N62661.AR.003456  
NS NEWPORT  
5090.3a

LETTER AND ATTACHED U S NAVY RESPONSE TO U S EPA REGION I AND RHODE  
ISLAND DEPARTMENT OF ENVIRONMENTAL MANAGEMENT COMMENTS ON THE DRAFT  
SAMPLING AND ANALYSIS PLAN FOR SOIL PRE-DESIGN INVESTIGATION DECISION  
UNITS 1-1, 1-2, AND 1-3 AT TANK FARM 1 (SITE 7) OPERABLE UNIT 13 (OU 13) NS  
NEWPORT RI  
10/29/2015  
RESOLUTION CONSULTANTS

RE: Response to Comments on Draft Sampling and Analysis Plan  
Soil Pre-Design Investigation (PDI)  
Decision Units 1-1, 1-2, and 1-3 at Tank Farm 1 (Site 7), OU 13  
Naval Station (NAVSTA) Newport, Portsmouth, Rhode Island

Navy Responses to Regulatory Agency Comments  
EPA Comments, September 10, 2015  
RIDEM Comments, September 29, 2015

**FIGURE 3**  
**CONCEPTUAL PDI SAMPLING**  
**LOCATIONS FOR DECISION UNIT 1-1**  
**ETHYL BLENDING PLANT**

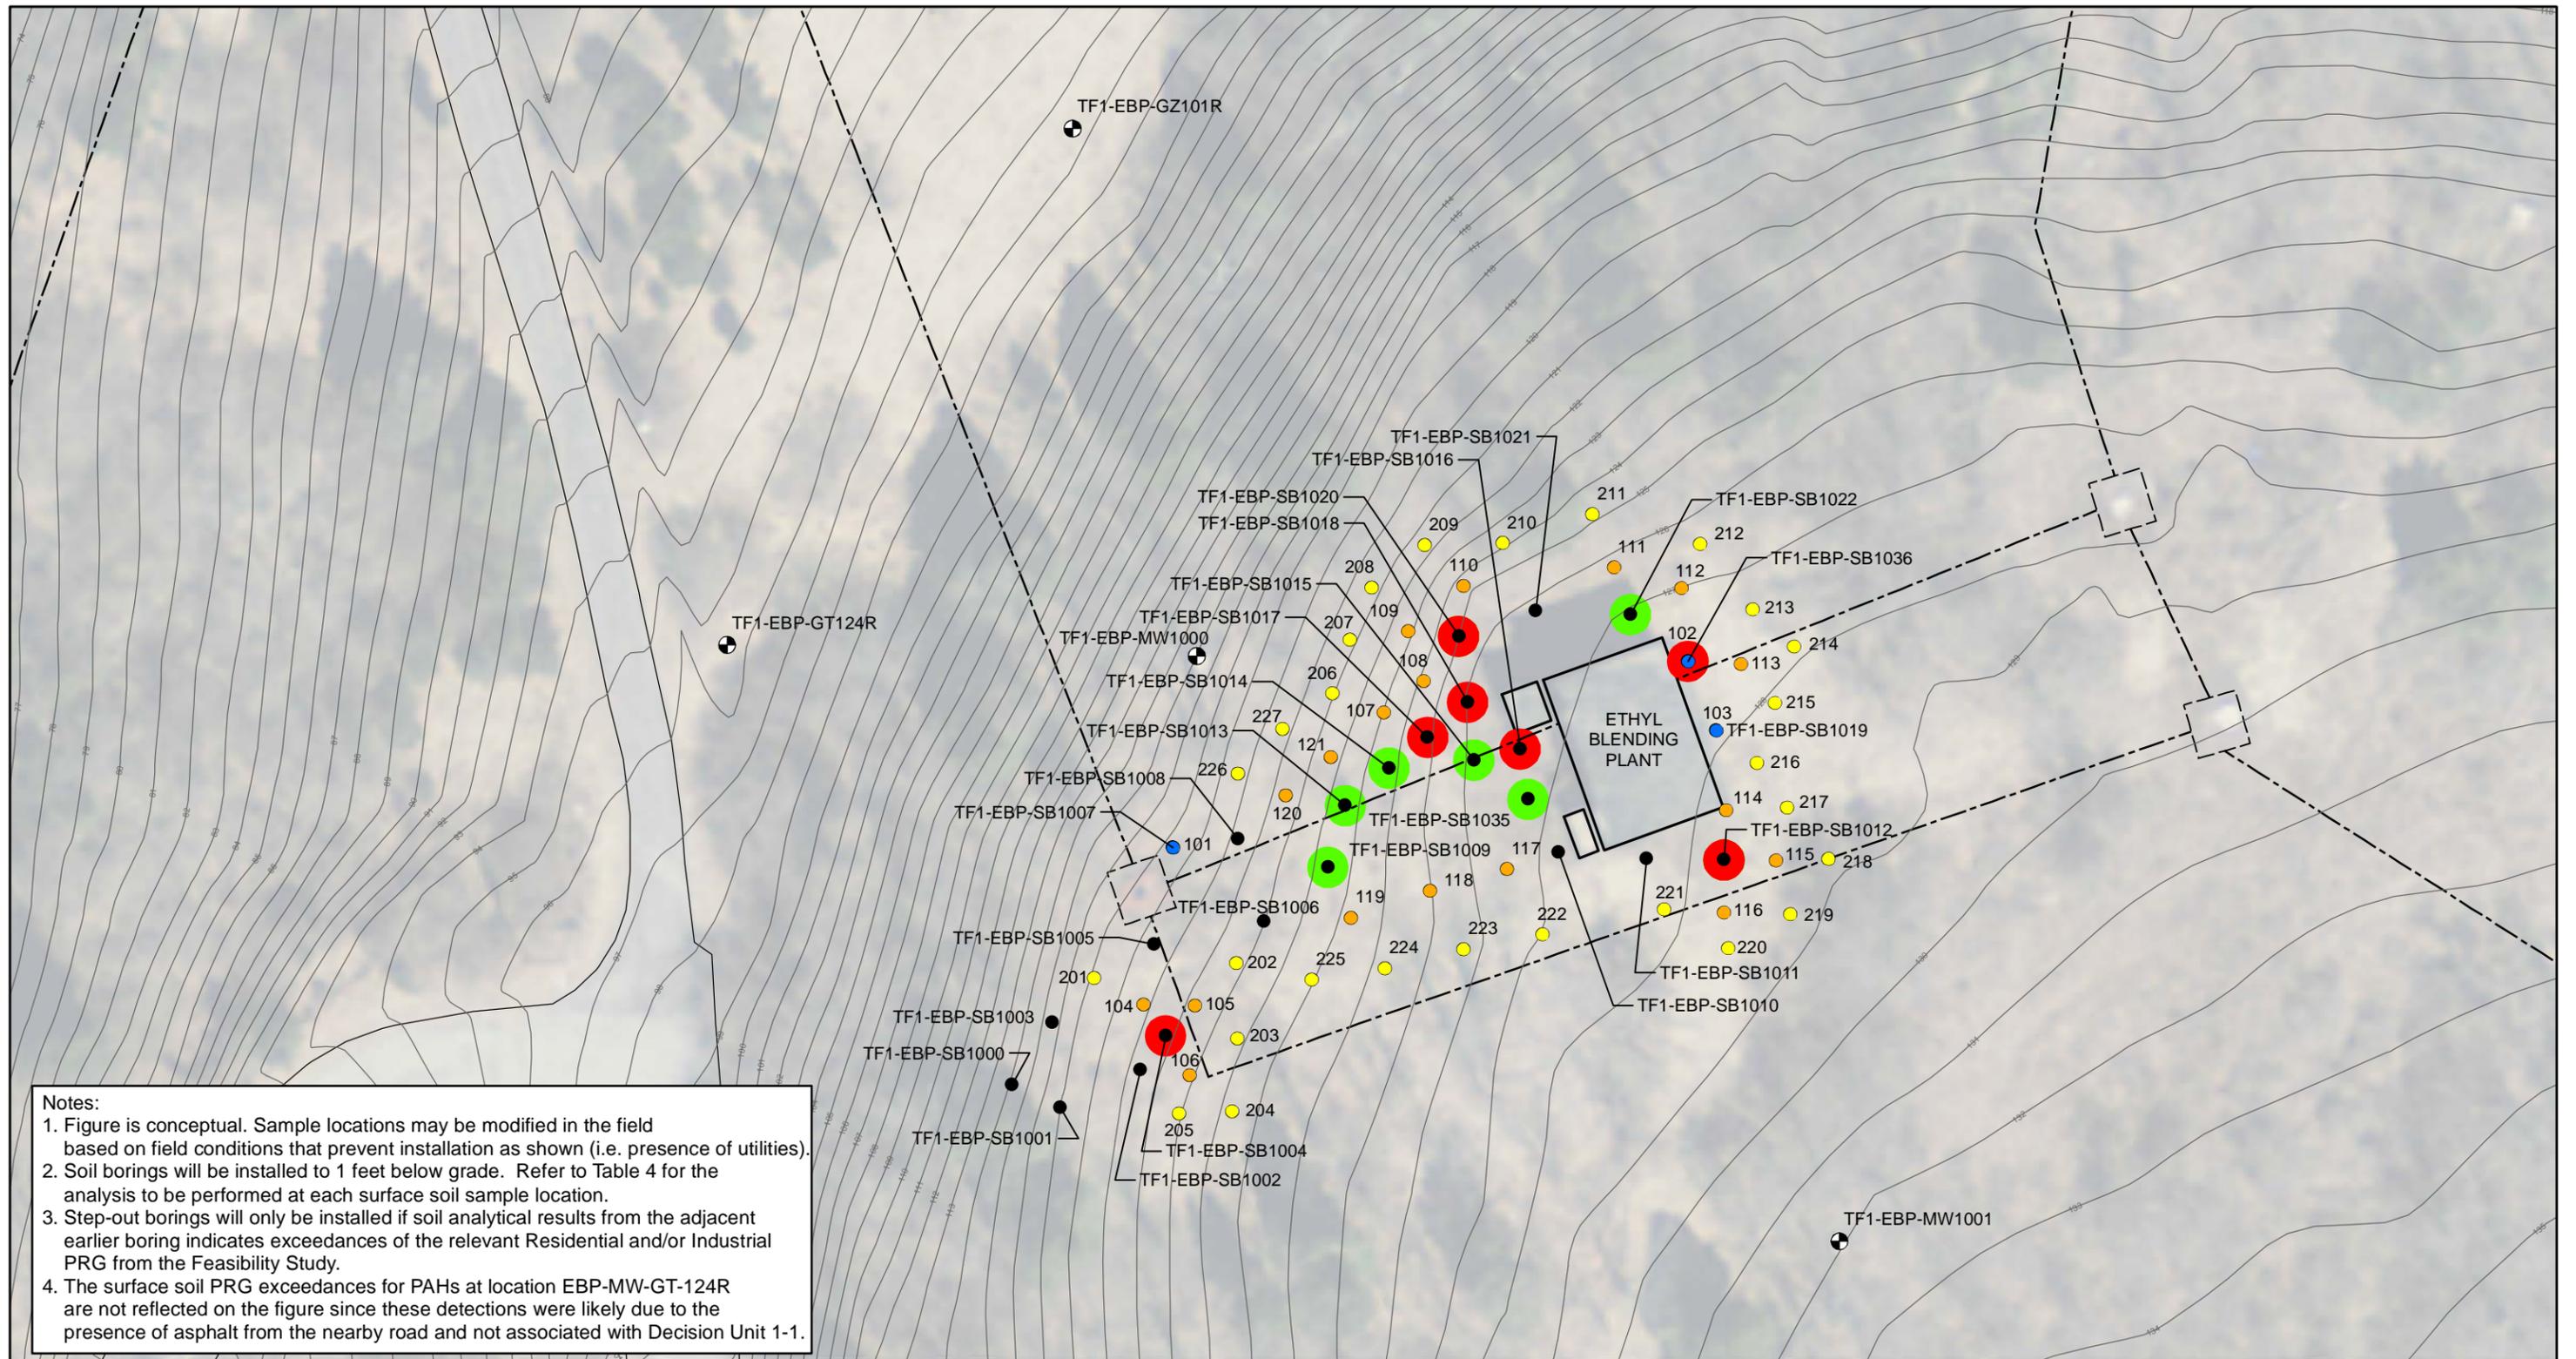
*EPA Specific Comment 5: Table 1 – In the future it would be helpful if the shading presented in this table matched the shading presented on the figures which designate exceedances.*

*EPA Specific Comment 11: Figure 3 – Please shift PDI samples 111 and 112 counterclockwise so 111 is directly down gradient of SB1024. Move 211 to be down gradient of relocated 111.*

Response: See the attached updated Table 1 with modified shading colors to match Figure 3.

Response: There is no SB1024. It is assumed that this comment was meant to refer to SB1022. The requested changes will be made. See the attached updated Figure 3.

**FIGURE 4**  
**CONCEPTUAL PDI SAMPLE LOCATIONS**  
**FOR DECISION UNIT 1-2**  
**TRANSFORMER VAULT 2**

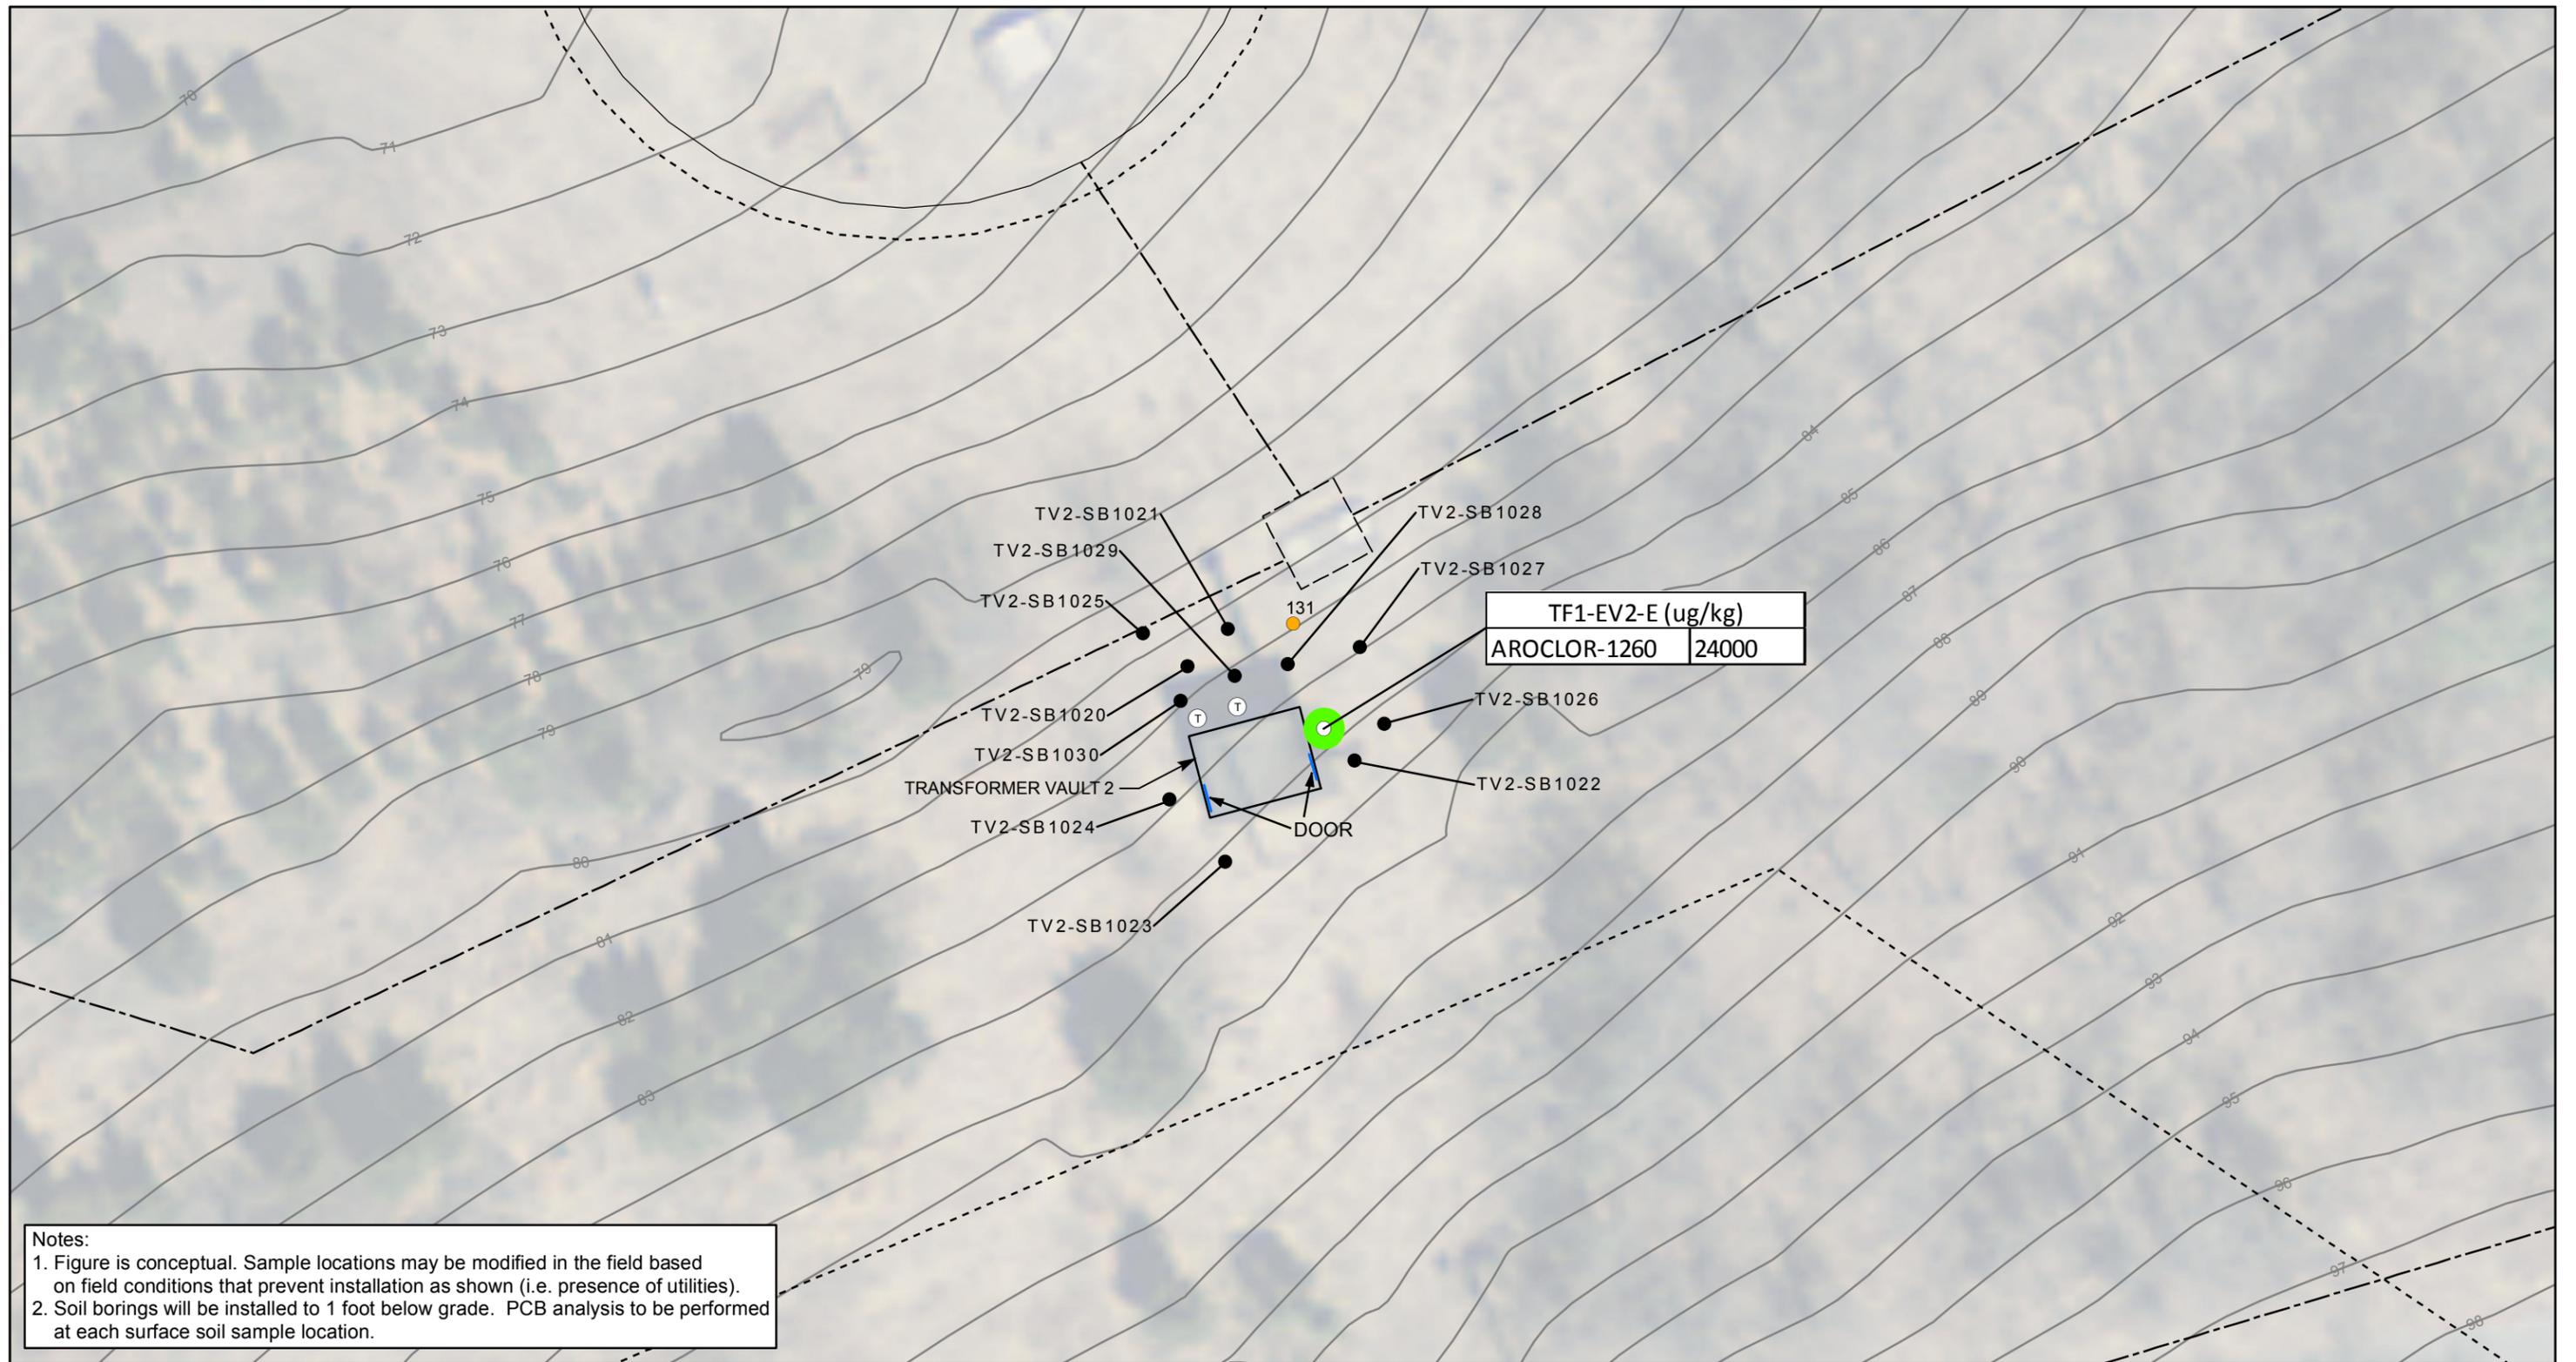
*EPA Specific Comment 3: Pg WS 10-4 – Please supplement this section with a summary of the previous investigations conducted at DU 1-2, including a figure. EPA requests that one sample be collected due north of SB1028 (1,000 µg/kg PCB) and east of SB1021 to verify the down gradient extent of PCBs associated with sample EV2-E (24,000 µg/kg).*

Response: The title of the SAP will be modified to include DU 1-2 and minor edits made throughout the SAP to reflect that this DU is now included in the PDI. The requested sample will be added. See attached new Figure 4 which shows the proposed location (boring 131). Also, see the new Table 2 (attached), which provides the historical surface soil data for DU 1-2. The existing tables and Figure 4 will be renumbered accordingly. The updated Tables 4 and 5 (previously 3 and 4) are also attached. This boring will also be added to the Sample Details Table (SAP Worksheet #18, 19, 20, and 30).
